E2E UI PROJECT 1791422533478 - FACILITY AUDITS REPORT

E2E UI FACILITY 1791422533478

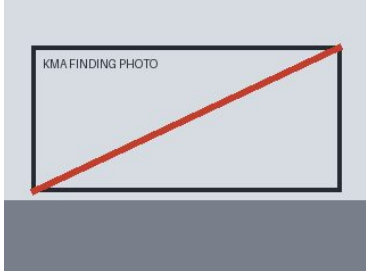
#	Barrier Statement	Code	Photo	Proposed Mitigation	Cost
1.	The curb ramp is not located on an accessible route. Measurement: 9.5% Location: UI entrance	ADAS 402.2		Rebuild the curb ramp on an accessible route. Quantity: 3 Unit Cost: \$1,250 EA	\$3,750
TOTAL FOR E2E UI FACILITY 1791422533478: \$3,750
